Interactive Discussion: Author Response to Referee #1

A downward counterfactual analysis of flash floods in Germany

NHESS Discussions, doi:10.5194/nhess-2023-224

Figure 1: Quick runoff (blue line) and areal average effective rainfall (blue bars) for the Altenahr basin. Red dotted lines: centroid of effective rainfall and QR peak

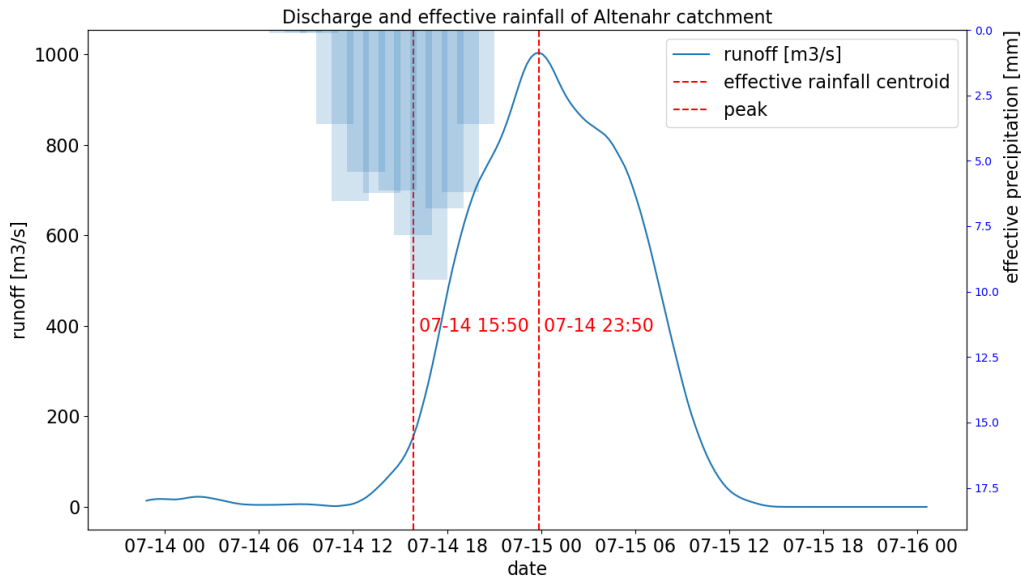
RC: *Regarding our case study “Flood 2021/Ahr”: Be careful... The flood event in July 2021 is a prominent example – but it is not a flash flood event (see title of your paper)? You need to discuss (or argue) this carefully.*

AR: Thank you for pointing out this issue. In fact, the flood peak arrived at Altenahr about eight hours after the centroid of the effective rainfall (according to our model, see Fig. 1 in this response letter). According to the most common definitions, a flash flood has a lag time of up to six hours between the flood peak and the centroid of the effective rainfall (Marchi et al., 2010, Morin et al., 2002). So the flood event down to Altenahr misses this criterion by two hours.

Still, several sub-basins within the Altenahr catchment show a very swift runoff peak within less than 6 hours. 22 out of 23 headwater catchments even have a lag time of less than three hours.

Given all these reasons, we fully agree with the referee that the choice of this case study warrants a careful justification to the audience. We therefore suggest to add an explanation at the beginning of section 4.2, after line 235 of the preprint:

Typically, a flash flood is characterized by a lag time of up to six hours between the centroid of the effective rainfall and the hydrograph peak (Borga et. al., 2008; Marchi et al. 2010, Morin et al., 2002). So, strictly speaking, the flood event at Altenahr does not qualify as a flash flood: according to our model, the lag time at Altenahr amounted to approximately eight hours. Still, the event at Altenahr is a highly illustrative example for a swift and massive runoff response at the meso-scale which is the result of the temporal superposition of various upstream flash floods. In fact, all 23 sub-basins upstream of Altenahr show a lag time of less than 6 hours, 22 of them even less than 3 hours.

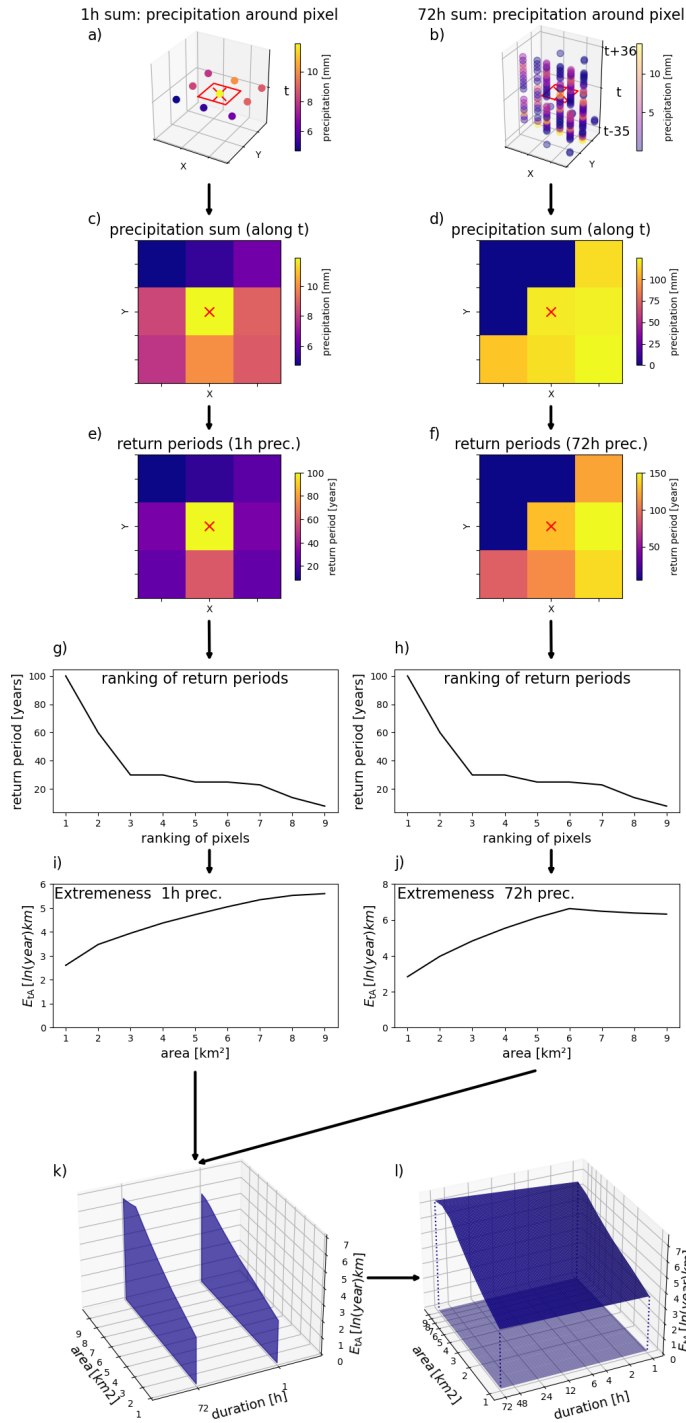
RC: *L117: "...high, if the rainfall in the 3 km x 3 km neighborhood was extreme at multiple durations (between 1 h and 72 h)." Perhaps add an example to make it easier for the reader to understand?*

AR: We have developed a figure in order to explain this better. As this figure, however, is quite bulky, and as not all readers might be interested in this level of technical detail, we suggest to shorten, in the main article, the explanation of how the catalog was generated. Instead, we provide a more detailed explanation, together with the new figure, in the supplementary material and refer to this in the main text.

In the supplementary, we suggest to use Fig. 2 for illustrating the process (you can find the figure at the end this PDF because it is quite large):

The catalog was created as follows (see also Fig. S1) for illustration). For simplification we just used only two durations in Figure S1 (1 and 72 h), while in our actual study we used eight durations (1, 2, 4, 6, 12, 24, 48, 72 h):

1. We applied a 3 km x 3 km x 72 km) moving window for each pixel in the RADKLIM dataset. In Figure S1 a) and b) the pixel is surrounded by a red box. In this moving window we aggregate the rainfall to the durations to respective durations (Figure S1 c) and d). For each duration we calculate the return periods for every pixel in the moving window (Figure S1 e) and f)). Now we can compute the xWEI. The return periods get sorted by decreasing order (Figure S1 g) and h). We then compute the extremeness, E_{tA} based on Müller et al., 2014:

Figure 3: Distribution of subbasin sizes in the study area. The blue line indicates the median size, the red lines the 25- and 75-percentile.

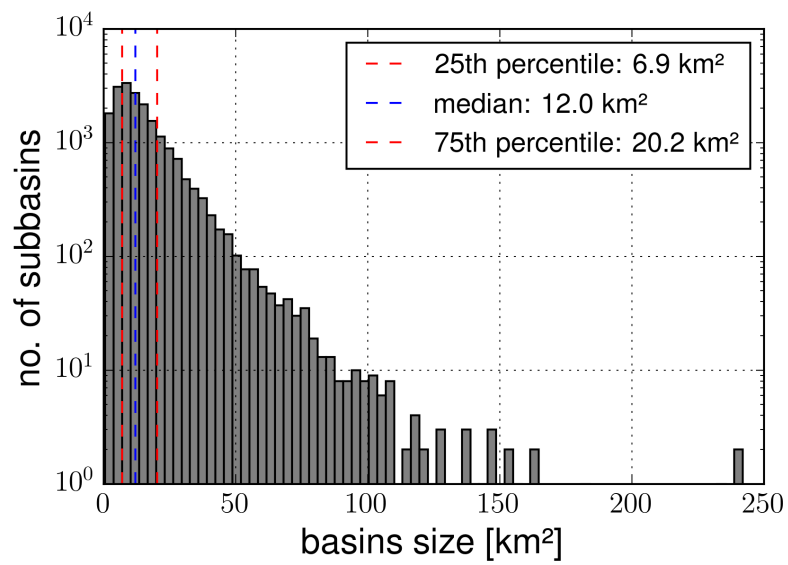
RC: L1334: *“The median basin size is 11.55 km².” Idea/Suggestion: Add a histogram of all catchments; including quartile values (25 %/75% percentile).*

AR: Thank you for this suggestion. However, we think that providing the median and the interquartile range in the

main manuscript already provides a good idea of the sub-basin sizes. We will add Figure 3 with the histogram to the supplementary material. We also apologize that we were using a wrong value in the pre-print. The median basin size is not 11.55 km² but 12 km².

The median basin size is 12 km² (25th percentile: 6.9 km², 75th percentile: 20.2 km²). Figure S2 (supplementary) illustrates the distribution of subbasin sizes as a histogram.

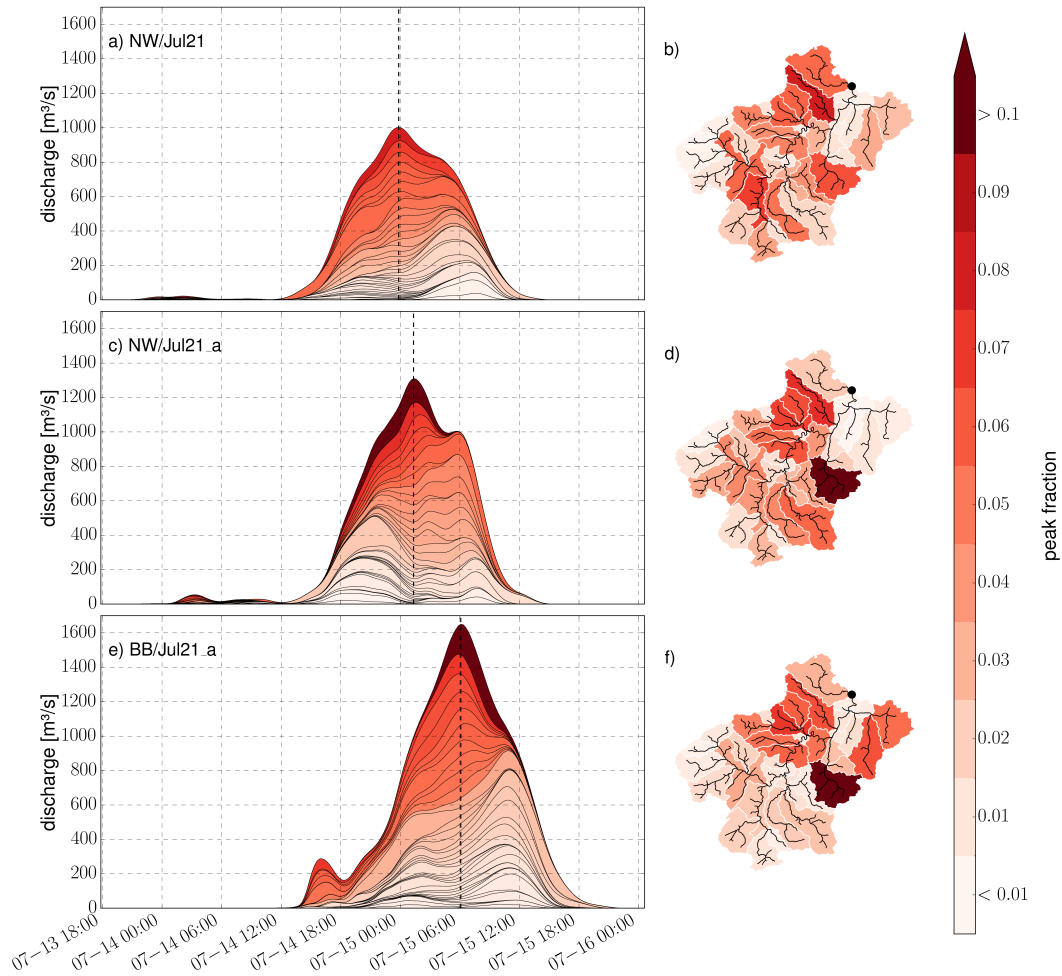
RC: *L247: “the QR peak can vary by a factor of 2.” Can you give a reason (or hypothesis) why this is the case?*

RC: *Figure 4: Can you explain one or two sentences about “stream order“ for the reader who is not so familiar with hydrology?*

AR: We hope to illustrate this in the new version of Figure 4 (which is discussed in the answer to the following

referee comment). The spatio-temporal distribution of rainfall has a large influence on the peak formation, leading to remarkably different peaks.

After your remark, we looked at the Figure again and revised it entirely. Our main intention with this Figure is to show the range of possible flood peaks due to the spatio-temporal signature of the rainfall and the possible superposition of peaks from different subbasins. We decided to not use stream orders anymore. The Figure now shows the contribution of the subbasins to the flood peak at Altenahr. We think that the new figure is now much clearer and more informative. In this regard, we also decided to just show 3 cases, and leave out NW/Jul21_b because it clearly has a different structure of precipitation and does not show episodes of high intensity rainfall. Besides, NW/Jul_b is not a "downward" counterfactual because of the rather low peak. This will simplify section 4.1.

Figure 5: Map of the study region (Germany): topography, major water bodies (blue), federal states (black), and selected cities (red); white: subbasins of the Ahr catchment upstream of Altenahr (case study region, see section 4.2).

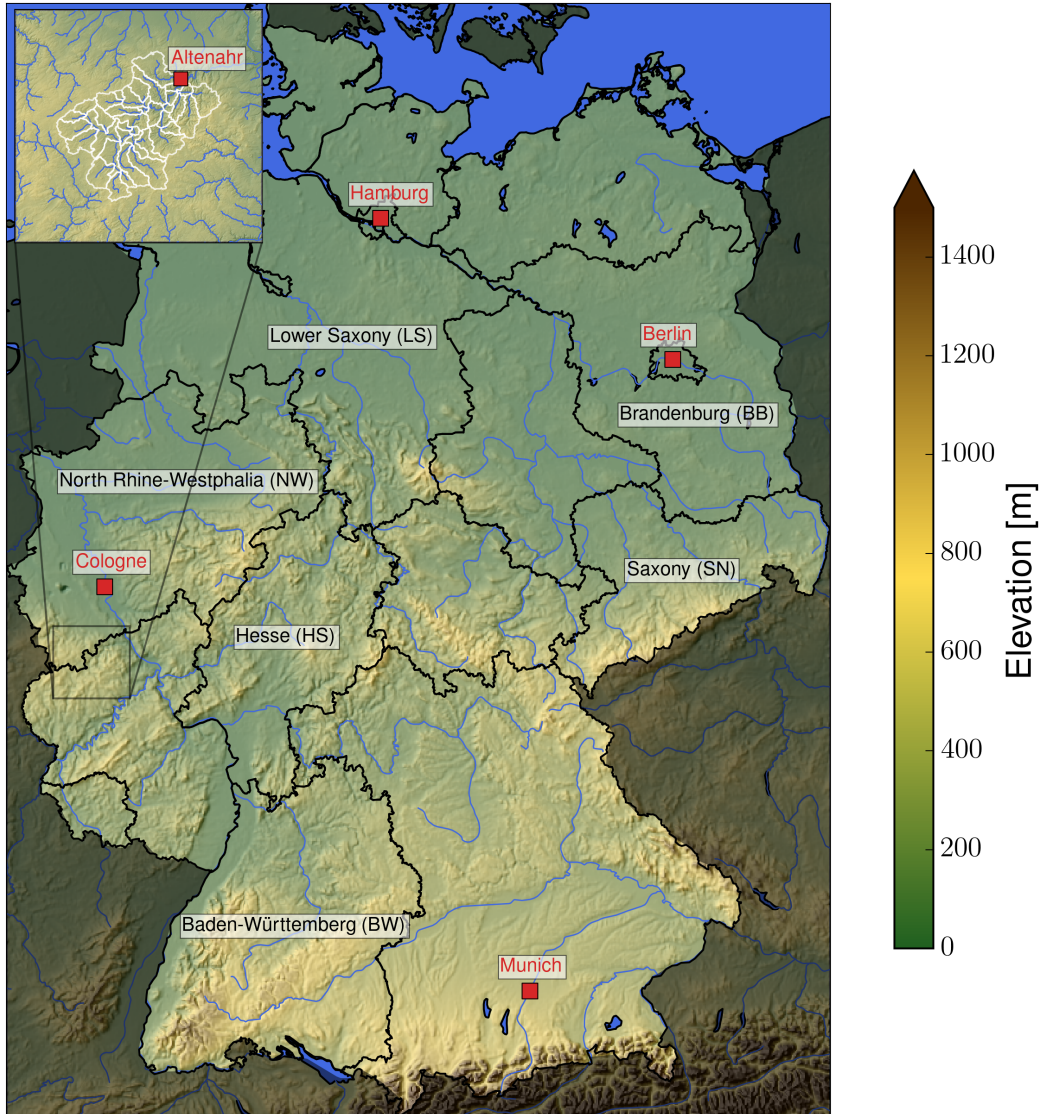
RC: *In some passages, I would wish more context for readers who are not familiar with the topic (or from other disciplines). (More complex) figures could be better introduced: what is the motivation of the figure or what exactly does the figure show before starting the interpretation (e.g. Fig 3, 4, 6). In addition, the authors do not take international readers into account – for them a figure with relevant names (cities, mountains) would be very helpful; this figure should also contain the orography that is relevant for the interpretation of Figure 5.*

RC: *L288f: “Mountain and low mountain ranges such as the Harz mountains, Ore mountains, the Black Forest” International readers need a figure that contains relevant location information; this could also include the orography so that the relationship is clear to them.*

AR: We agree, that the international reader might not be able to relate to these locations. Therefore, we suggest to drop the names of the areas entirely and just mention "mountain ranges". Following your suggestion, we will add Fig. 5 at the beginning of section 2.1 which clearly shows the topography of Germany, the names of the federal states, some major cities and rivers, as well as a zoom to the Ahr catchment upstream Altenahr. We hope that this figure will help the readers to contextualize the results of our study.

Mountain and low mountain ranges (compare to Fig. 1) display high QR peaks and therefore high UPD in the downward counterfactual analysis.
